STATE OF WASHINGTON  
DEPARTMENT OF ECOLOGY

December 14, 2016

**Re: Further Action at the following Site:**

- **Site Name:** Adams Street Building
- **Site Address:** 6707 S Adams Street, Tacoma, Washington 98409 Pierce Co.
- **Facility/Site No.:** 7177
- **VCP Project No.:** SW1530

Figure 2

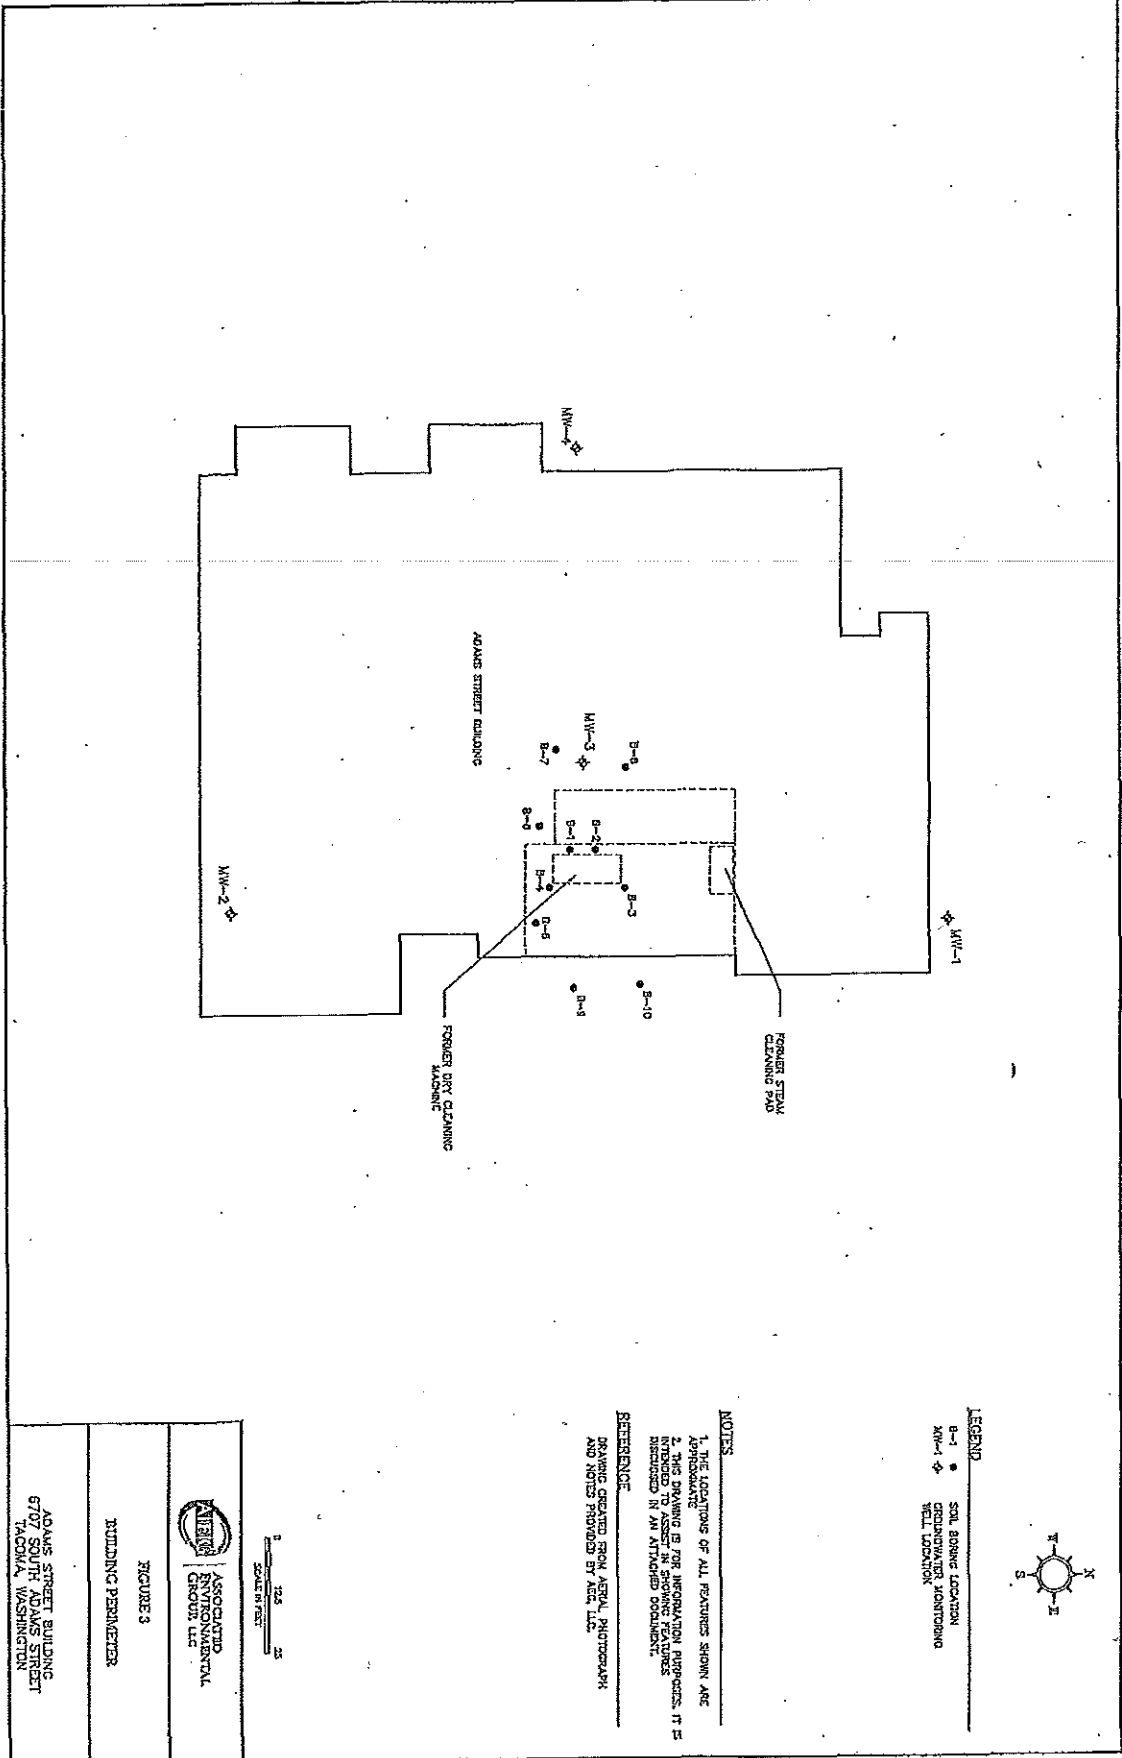
- d. AEG's Site Map (Figure 2) and Building Perimeter (Figure 3) show an unlabeled dashed outline to the west of the former steam cleaning pad and former dry cleaning machine. Please identify this feature.
